**RE: Christensen Oral Surgery
9378 Valley View Dr. NW
Grading & Drainage Plan
Engineer's Stamp Date: 03/27/2025
Hydrology File: C13D025F
ABQ-PLAN File: HYDR-2025-00034**

Based upon the information provided in your submittal received 04/03/2025, the Grading & Drainage Plan is **approved** for a Grading Permit, Building Permit, and Work Order. Please include a copy of this stamp approved plans in the construction set for Building Permit processing along with a copy of this letter.

GRADING & DRAINAGE PLAN

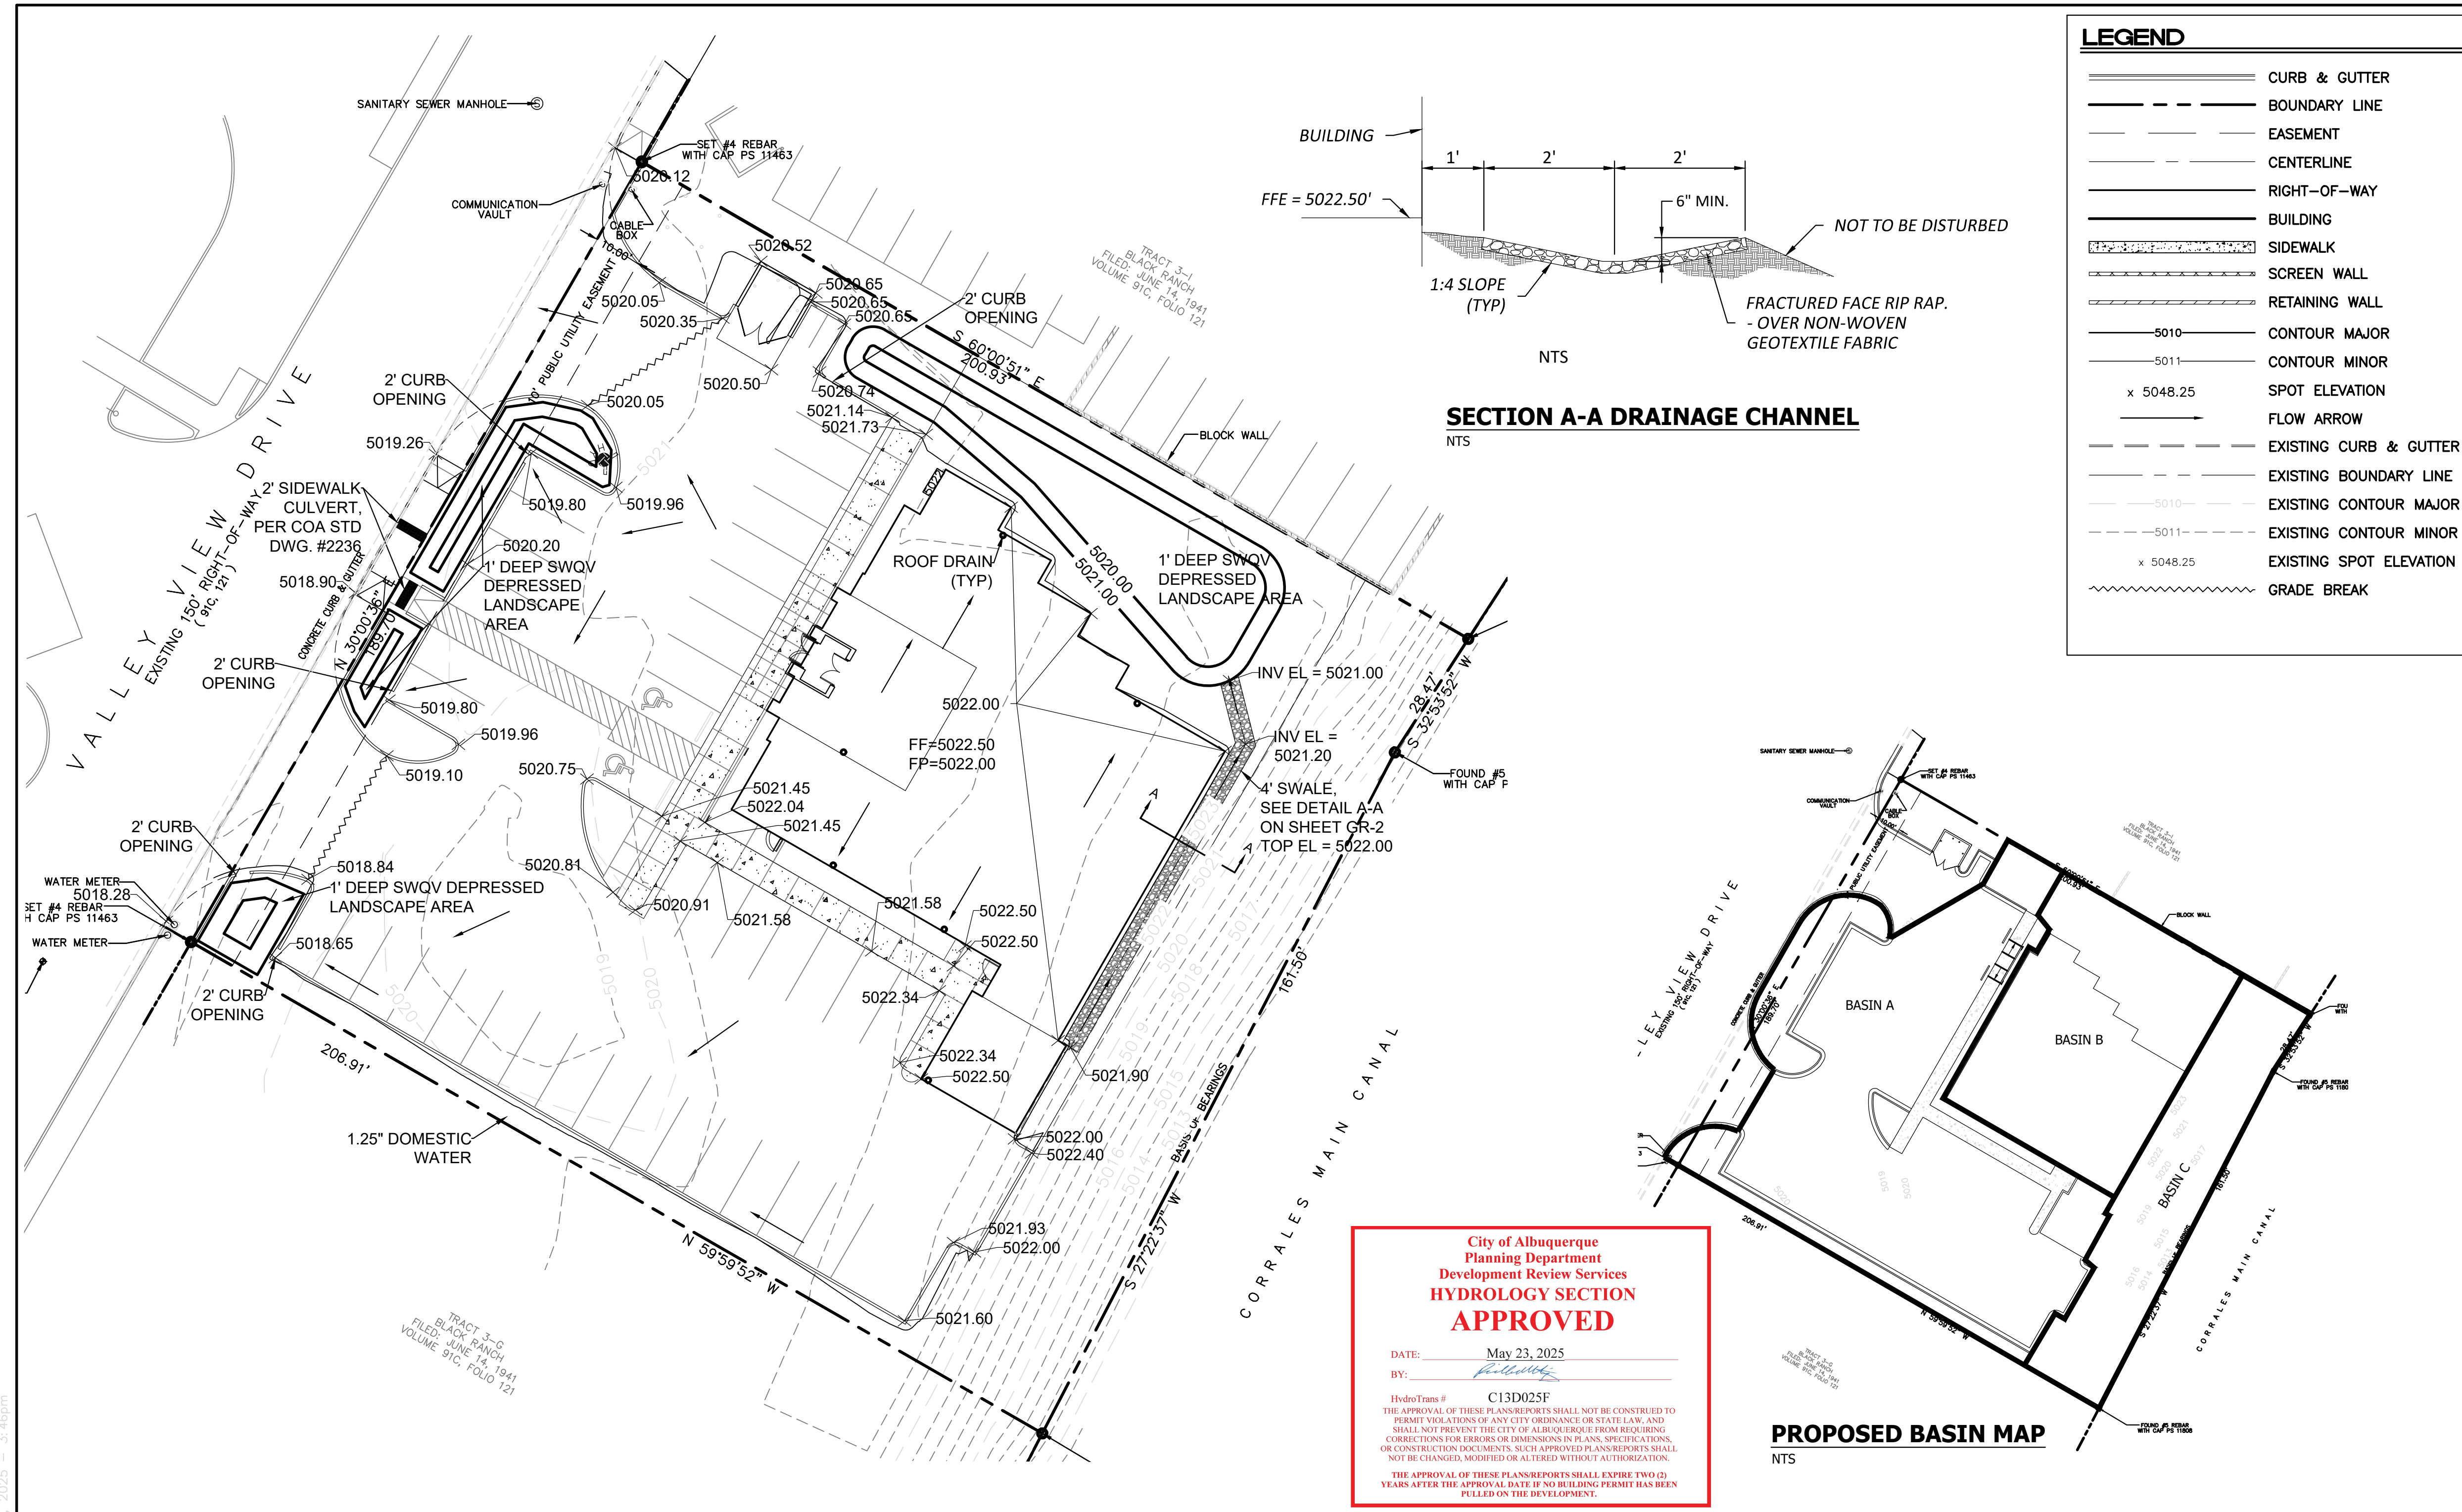
PRIOR TO CERTIFICATE OF OCCUPANCY:

1. Engineer's Certification, per the DPM Part 6-14 (F): *Engineer's Certification Checklist For Non-Subdivision* is required.
2. Prepare and provide Drainage Covenants for the detention ponds and private storm drains per Chapter 17 of the DPM prior to Permanent Release of Occupancy. Please submit on the 4th floor of Plaza de Sol. A \$25 fee will be required.
